Clarence Colliery - EPBC Referral 2024/09856

Preliminary Documentation

E241091 RP2

Clarence Colliery
Figure 2.1

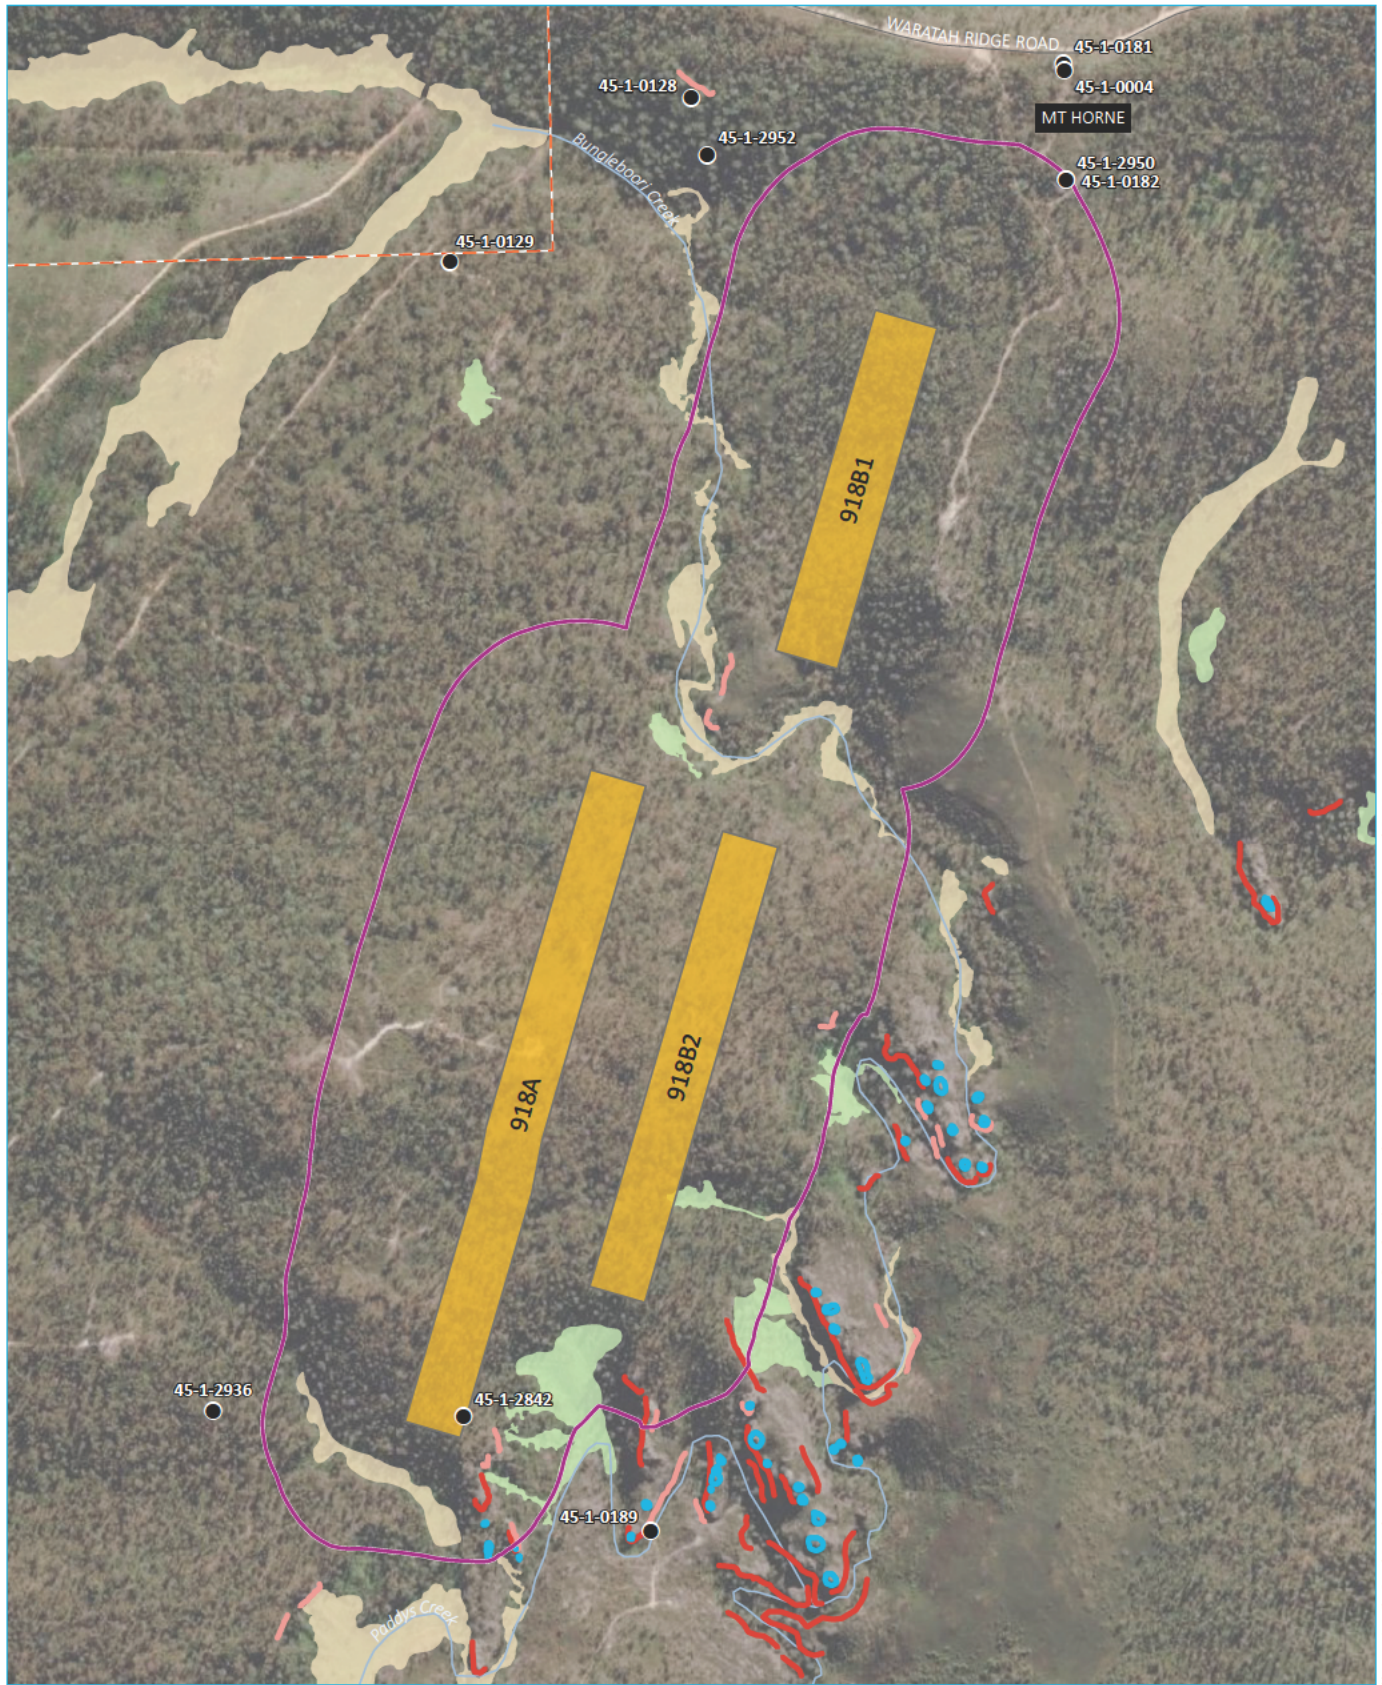
In July 2024, DCCEEW determined that the extraction of 918 and 920 Panels, and associated activities, are a controlled action (2024/09856). The controlled action decision raised concerns regarding uncertainty associated with the mining technique (PPPE using shortwall). In response, the risk of impacts to MNES and has been significantly reduced by avoiding direct mining beneath most THPSS and third order streams, and by reducing proposed Action area and disturbance footprint. It should be noted that no vegetation clearing is proposed and the disturbance footprint corresponds to the revised second workings areas on Figure 2.1 and Figure 2.2.

In November 2025, the controlled action was varied to remove 920 Panel and parts of 918 Panel. The design changes are illustrated in Figure 2.1 and Figure 2.2.

Overall, the revised mine plan has resulted in a reduction of the proposed Action area by approximately 57.4 ha compared to the proposed Action area identified in the original 2024/09856 referral.
